Access Compliance Report

Public Rights-of-Way

(Curb Ramps)

Intersection ID: 10777	Main Street: WESLEY_AV	Cross Street: WHITING_AV	Location: E
ADA ID: 8534C91DB654	Ramp Type: Perp	Initial Pass/Fail: Fail	Overall Compliance: No
Severity Score: 12.5			
Codes/Mitigation Info/Possible Solution		Field Measurements/Component Compliance

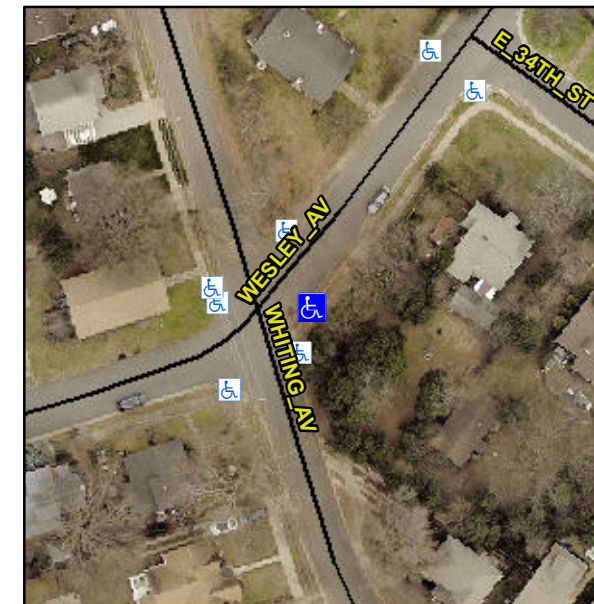
Not Found, R304.2.2

Compliance	Description	Data	Compliance	Description	Data
N/A	Ramp Length (in)	48.0	No	Ramp Slope (%)	11.4
Yes	Ramp Width (in)	48.0	Yes	Ramp XSlope (%)	0.0
N/A	Flare Type LT	N/A	N/A	Flare Type RT	N/A
N/A	Flare Slope LT (%)	N/A	N/A	Flare Slope RT (%)	N/A
N/A	Flare Traversable LT?	N/A	N/A	Flare Traversable RT?	N/A
N/A	Landing Length (in)	N/A	N/A	DWS Provided?	N/A
N/A	Landing Width (in)	N/A	N/A	DWS Contrast?	N/A
N/A	Landing Slope (%)	N/A	N/A	DWS Length (in)	N/A
N/A	Landing X Slope (%)	N/A	N/A	DWS Full Width?	N/A
N/A	Landing Curb? (Y/N)	N/A	N/A	DWS Offset (in)	N/A
N/A	Shared Landing?	N/A			
N/A	Gutter Ponding?	N/A	N/A	Gutter Slope (%)	N/A
N/A	Gutter Lip Ht (in)	N/A	N/A	Gutter X Slope (%)	N/A
N/A	Painted X Walk1?	No	N/A	Painted X Walk2?	N/A
	X Walk 1 Direction	To N		X Walk 2 Direction	N/A
N/A	X Walk 1 Width (in)	N/A	N/A	X Walk 2 Width (in)	N/A
	X Walk 1 Slope (%)	0.3		X Walk 2 Slope (%)	N/A
	X Walk 1 X Slope (%)	1.2		X Walk 2 X Slope (%)	N/A

Remove & Replace Entire Ramp.
